**Compliance with Approval Condition (d)
Submission of a Run-in/out Proposal**

**Proposed Temporary Animal Boarding Establishment with Ancillary Facilities
for a Period of 5 Years and Filling of Land on Government Land
in D.D. 114, Kei Ling, Pat Heung, Yuen Long
(Application No. A/YL-PH/969)**

Compliance with Approval Condition (d)
Planning Application No. A/YL-PH/969
Response-to-Comments

Comments from the Chief Highway Engineer/New Territories West of the Highways Department

Plan 8a
(P 23009)

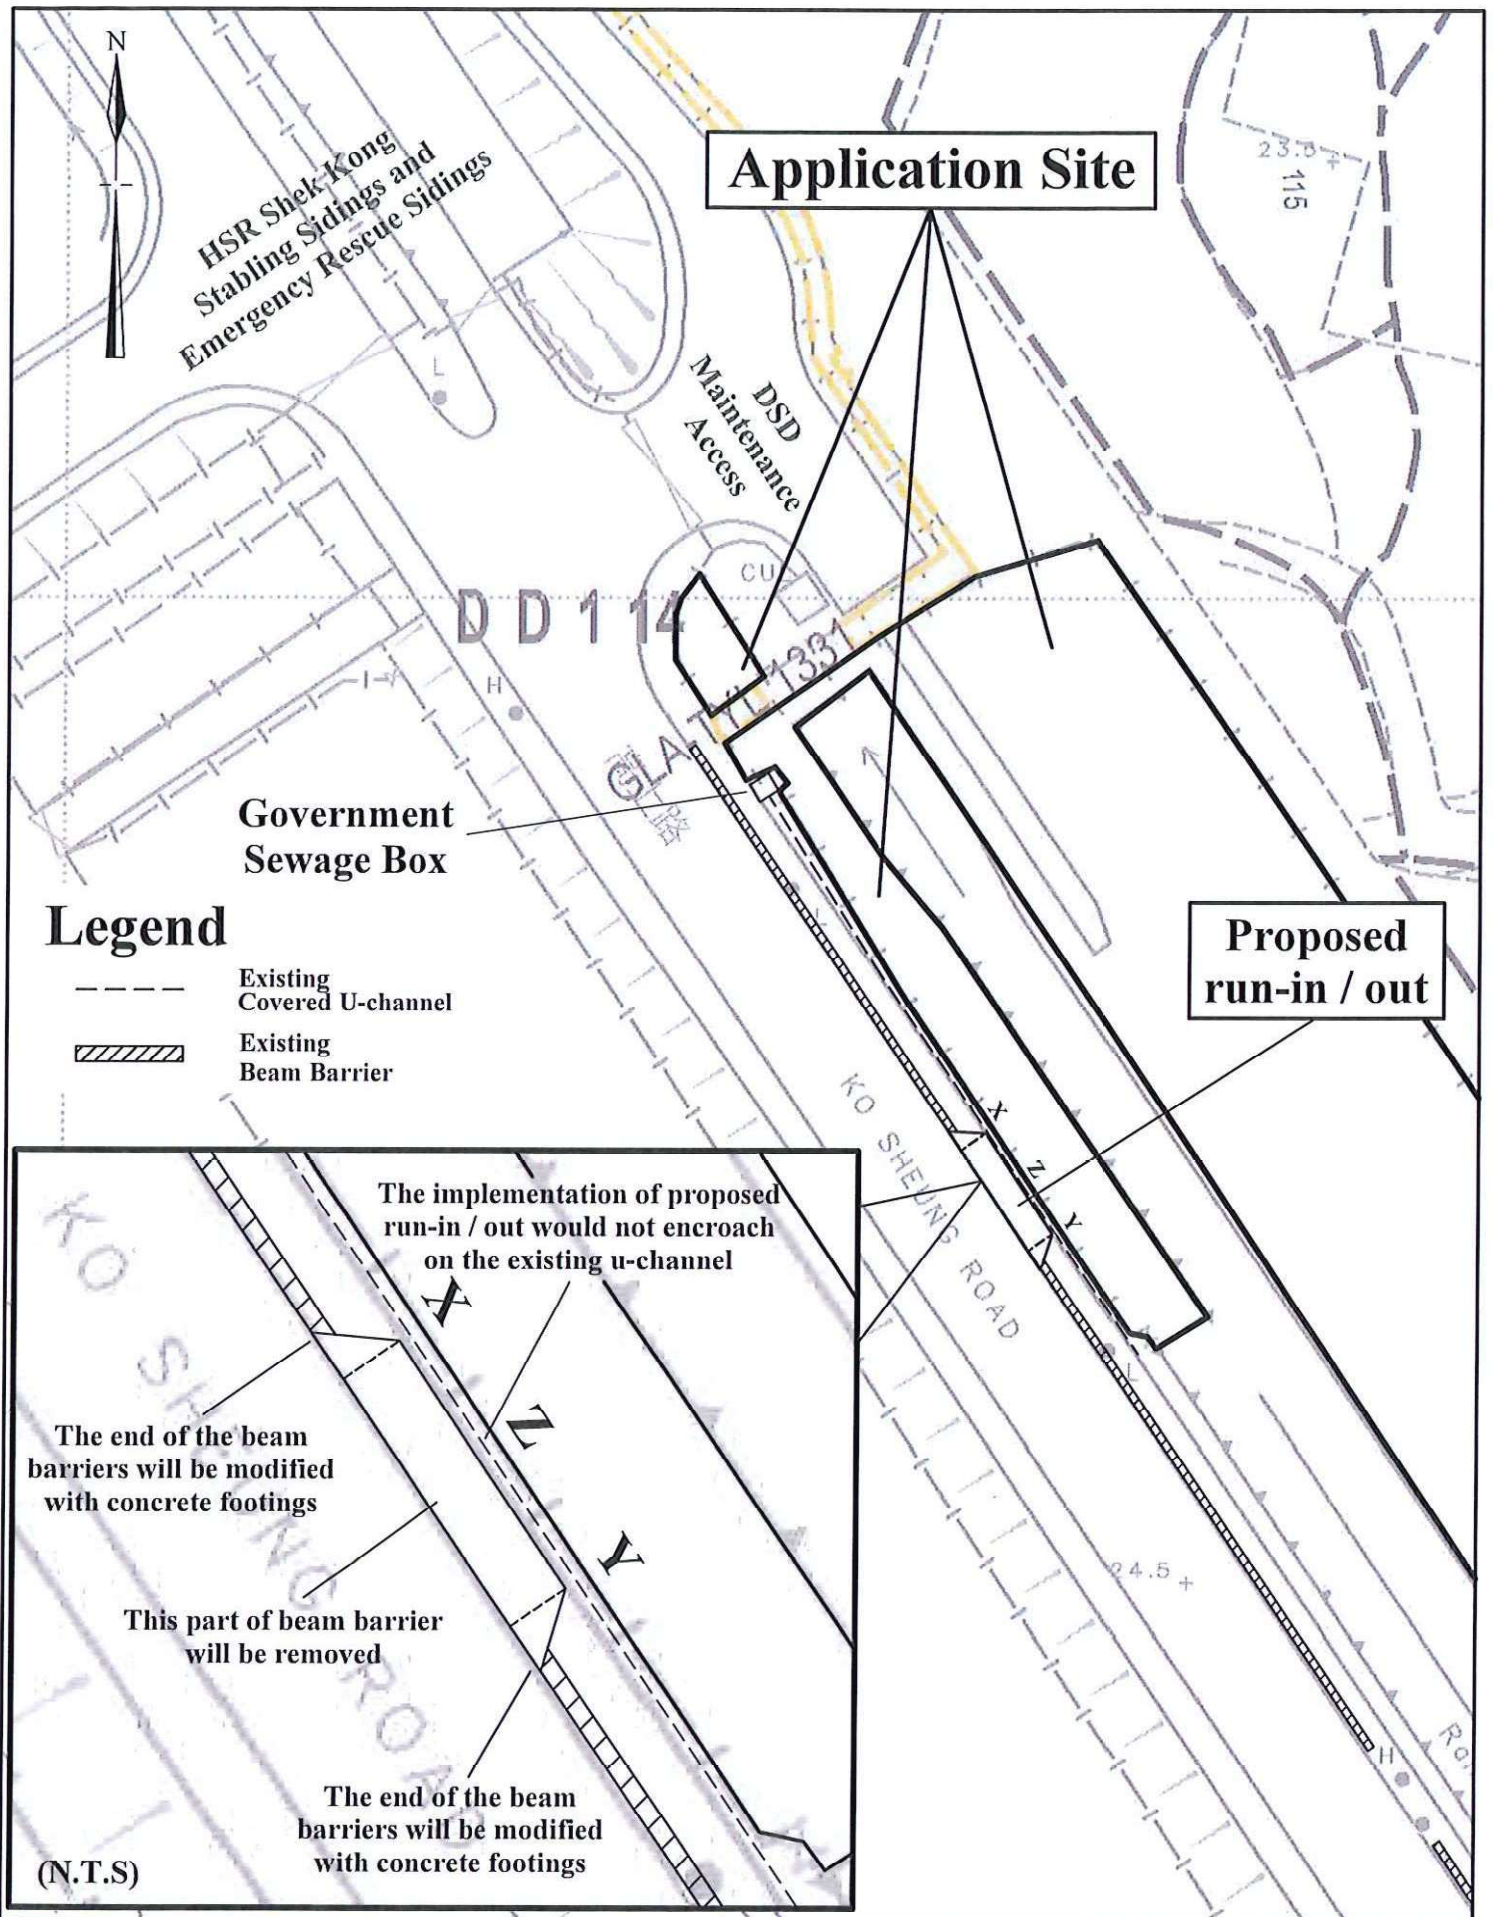
I.	Comment	Response
1.	The location of the proposed run-in/out should be consistent with the relevant planning application approved. For easy reference, the approximate distance of the run-in/out from the existing lamp post should be marked.	The location of the proposed run-in/out is consistent with the approved planning application. The distance between the existing lamp post and the proposed run-in/out is marked on Plan 8a .

**Plan 12
(P 23009)**

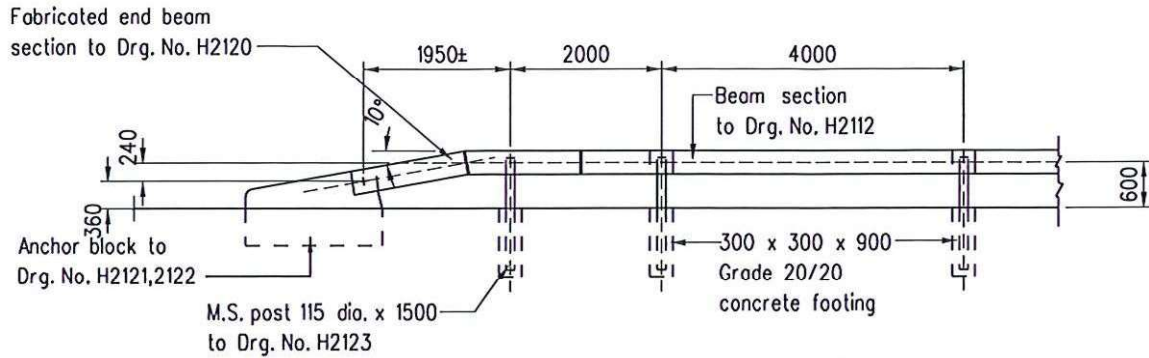
2.	To implement the proposed run-in/out, it is anticipated that the existing U-channel and covers, beam barriers and gullies would be affected. The proposal of modification/alteration/improvement of the relevant existing road features, if required, to facilitate the provision of the run-in/out is missing in the submission.	Please see Plan 12 for the existing road features and the improvement works. The implementation of the proposed run-in/out would not encroach on the existing U-channel. The existing U-channel and covers would not be affected. The beam barriers within the proposed run-in/out area will be removed and the two sides of the end of beam barrier will be modified with concrete footings according to Highways Department's Standard Drawings H2117D (Plan for roadside with anchor block and horizontal flare), H2119E (Section A-A) and H2120A when implementing the proposed run-in/out. There are no existing gullies within the proposed run-in/out area.

- (a) The exact location of the run-in/out and the termination points of the existing beam barriers at both sides are agreed by the Transport Department.

- (b) The existing U-channel and covers should be properly protected from drainage blockage or damages caused by the vehicular access. Any damages incurred shall be repaired and made good at the applicant's own cost, to the satisfaction of HyD.
